UNITED STATES PATENT AND TRADEMARK OFFICE

Office Action Summary	Application No. 10/540,326	Applicant(s) MADDOX ET AL.
	Examiner CHRISTOPHER BOSWELL	Art Unit 3673

DETAILED ACTION

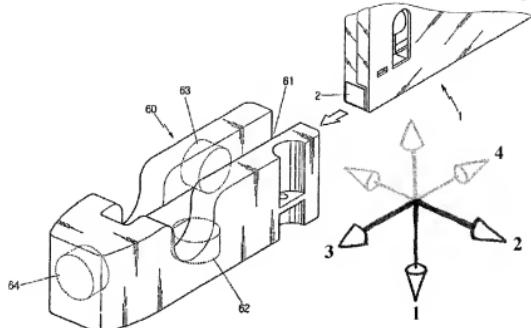
Applicant's arguments filed September 15, 2008 have been fully considered but they are not persuasive. First, the examiner points out that the applicant was mischaracterized the reference as shown in the figure in the remarks section. The examiner equated the first direction defined by the axis of magnet 62, and the second direction defined by the axis of magnet 63, and thus, the third and fourth directions are coaxial with the axis of magnet 64 (as shown below).

In response to the argument that Kim does not disclose a receptacle configured and adapted to receive first and second surfaces of an article that are wider than the apparatus and extend beyond the apparatus in a third direction and in a fourth direction opposite the third direction, the examiner respectfully disagrees. As shown above, the longitudinal length of the article is greater than the longitudinal length of the apparatus, and thus the article is capable of extending beyond the apparatus where the article is wider than the apparatus in the 3rd and 4th directions.

Regarding the argument that Kim does not disclose a receptacle adapted and configured to receive an article such that the size of the surfaces of the article within the receptacle are unrestricted in at least the third direction and a fourth direction opposite the third direction, the examiner respectfully disagrees. As the apparatus is open on one end, in the axial direction of magnet 64, the article is capable of being moved unrestrained in the third and fourth directions, as the third and fourth directions are coaxially aligned with each other.
